# HISTORIC AND DESIGN REVIEW COMMISSION

June 01, 2022

**HDRC CASE NO:** 2022-293  
**ADDRESS:** 1024 N CHERRY  
**LEGAL DESCRIPTION:** NCB 512 BLK 25 LOT W 99.55 FT OF 3  
**ZONING:** R-4, H  
**CITY COUNCIL DIST.:** 2  
**DISTRICT:** Dignowity Hill Historic District  
**APPLICANT:** Joseph Munoz  
**OWNER:** Joseph Munoz  
**TYPE OF WORK:** Construction of a rear addition, exterior modifications, fenestration modifications, porch modifications, roof form modifications, window replacement and siding modifications  
**APPLICATION RECEIVED:** May 17, 2022  
**60-DAY REVIEW:** Not applicable due to City Council Emergency Orders  
**CASE MANAGER:** Edward Hall

# FLOOR PLAN

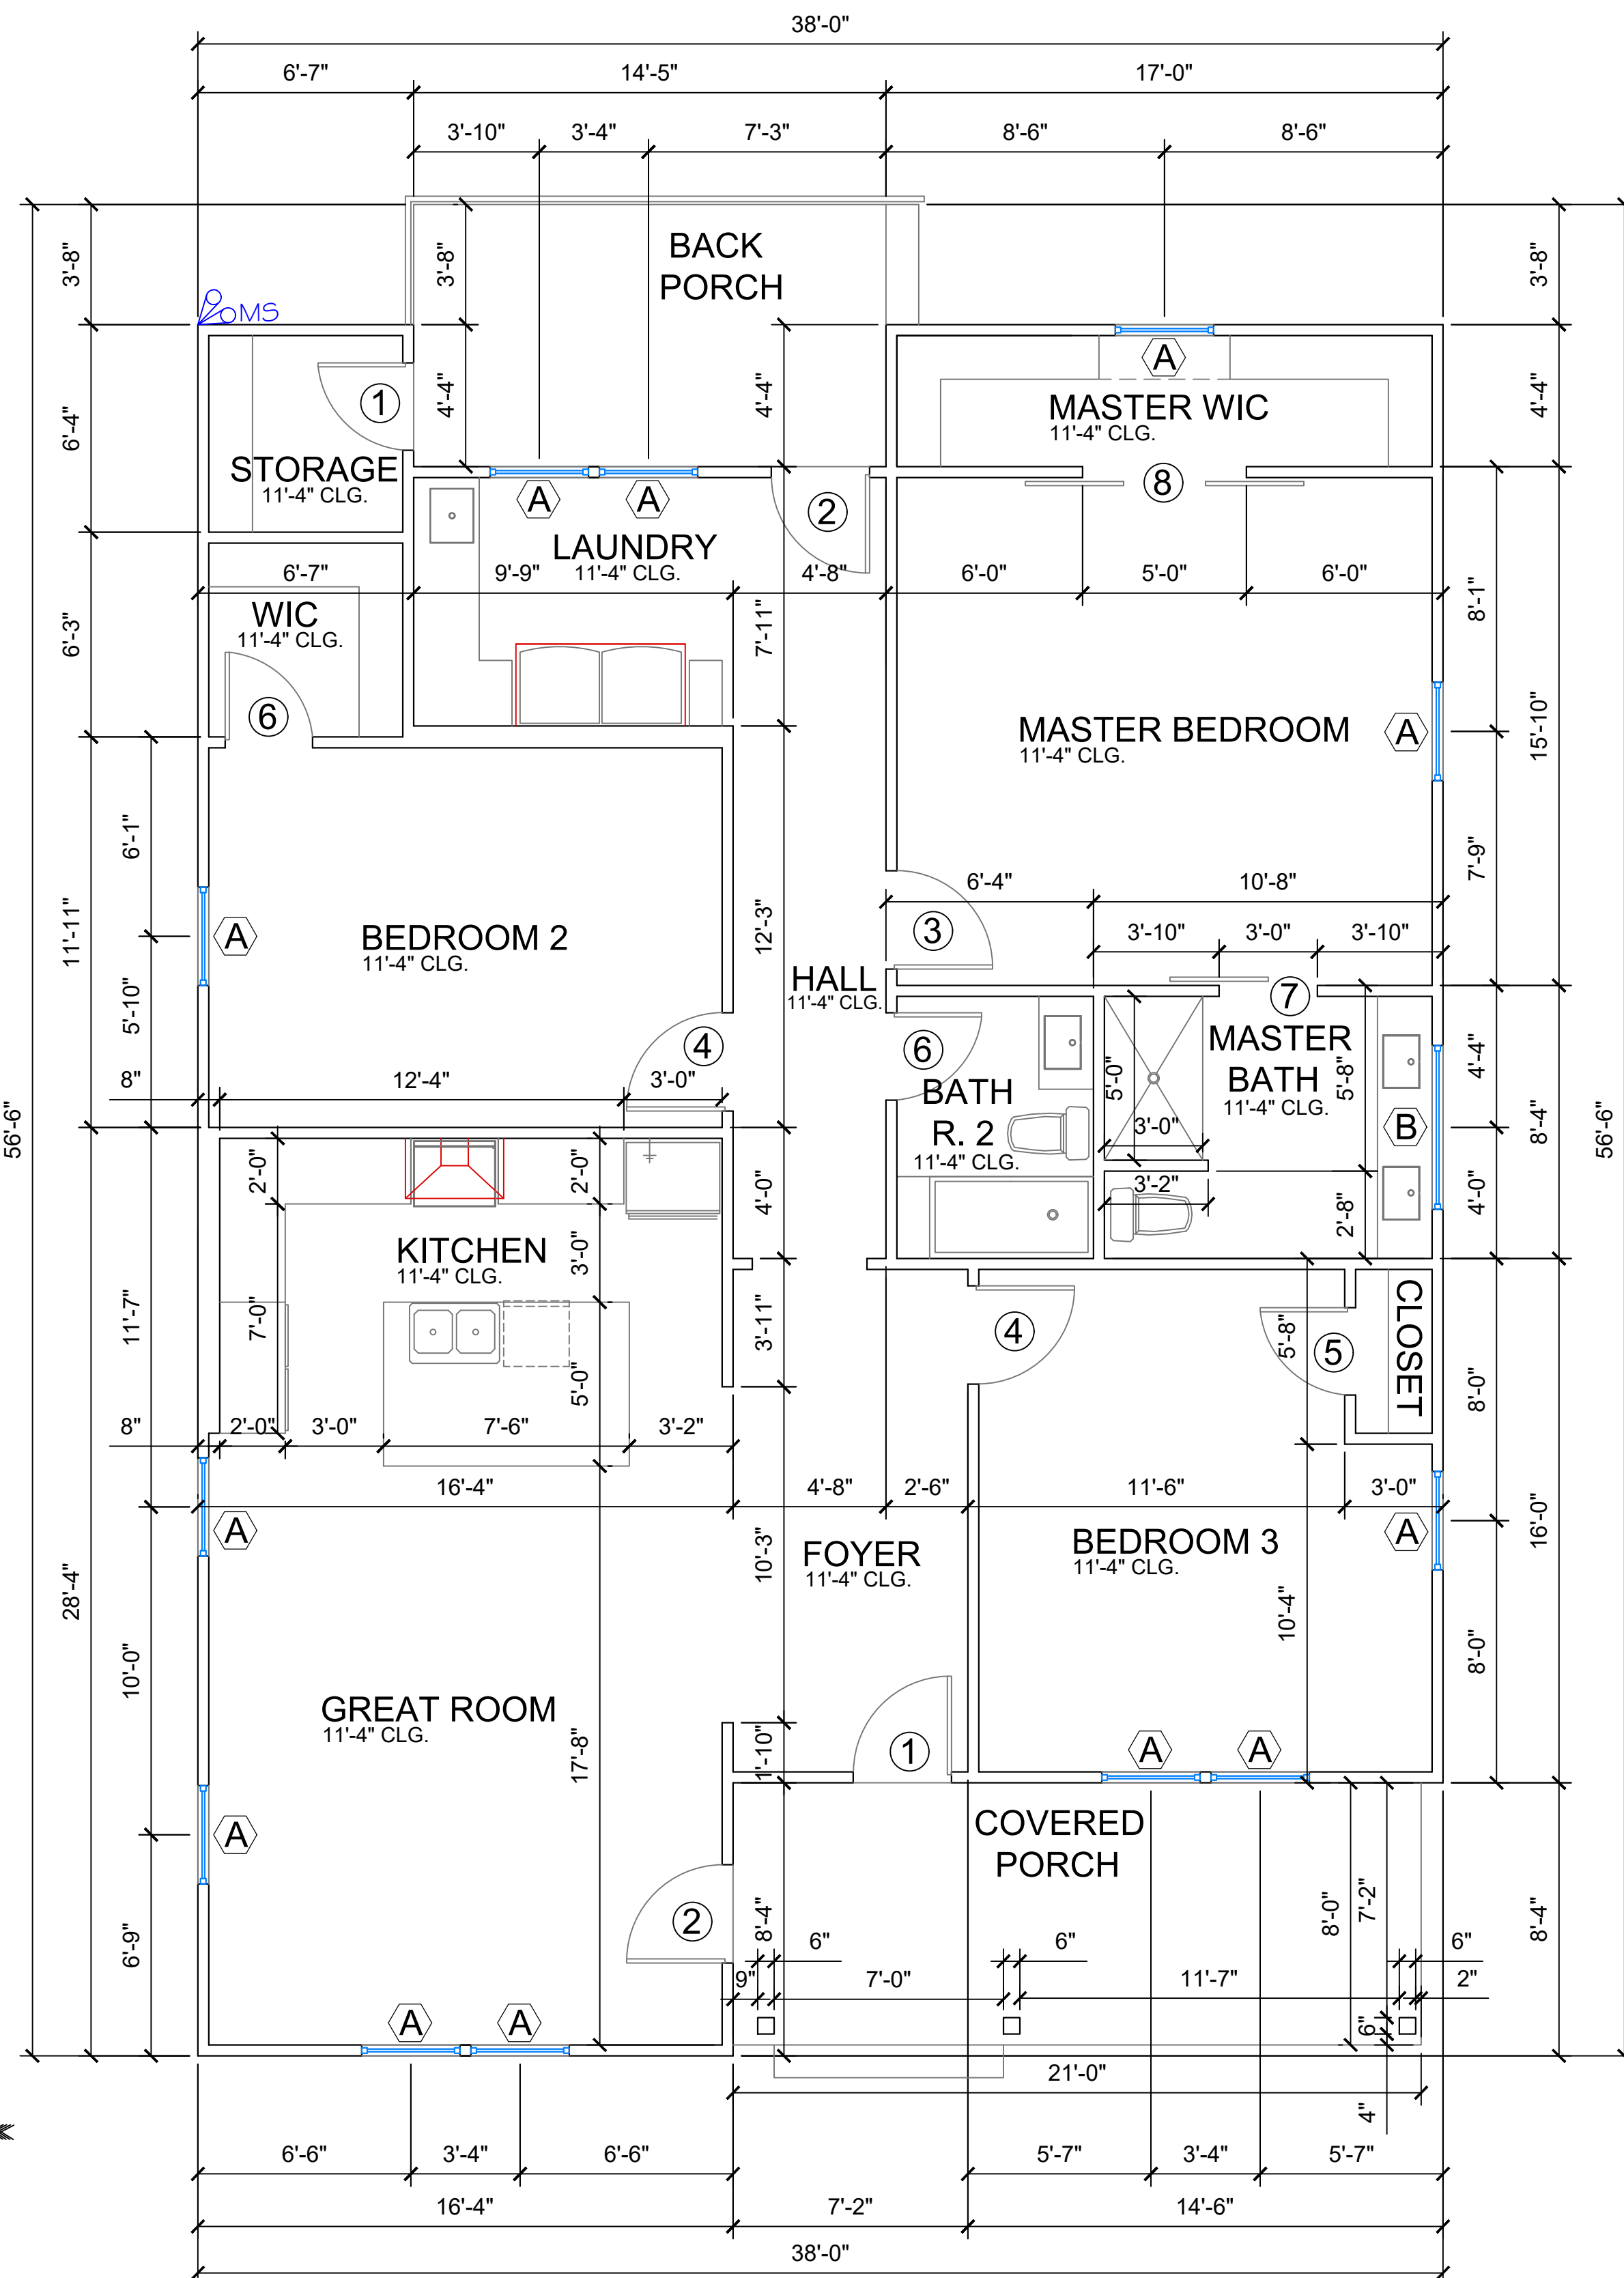
- i. REAR ADDITION – The applicant has proposed to construct a rear addition to feature approximately 350 square feet. The proposed rear addition will feature an open air, covered porch, a front facing roof gable, composite siding and aluminum windows.

- j. REAR ADDITION – The Guidelines for Additions 1.A. notes that additions should be sited to minimize view from the public right of way, should be designed to be in keeping with the existing, historic context of the block, should feature similar roof forms, and should feature a transition to differentiate the new addition from the historic structure. Additionally, the Guidelines for Additions 1.B notes that additions should be subordinate to the principal façade of the historic structure, should feature a footprint that responds to the size of the lot, and should feature an overall height that is generally consistent with that of the historic structure. The applicant has proposed an addition that does not feature a differentiating element between the historic structure and the rear addition as well as an addition that features a ridge line that is greater than that of the historic structure. Staff finds the proposed rear addition to be inconsistent with the Guidelines.

7. Staff does not recommend approval of item #7, the construction of a rear addition, based on findings i through m. Staff recommends the following for the rear addition:

- i. That the rear addition feature a setback from the walls of the historic structure or a separating element, such as a vertical trim piece.
  - ii. That the siding and trim feature a smooth profile and that siding feature an exposure of four inches.

- iv. That the proposed addition feature a massing that is subordinate to that of the historic structures, including a reduced roof form that does not impact the primary ridge line of the historic structure. The rear addition's roof should not impact the primary, front façade of the historic structure.
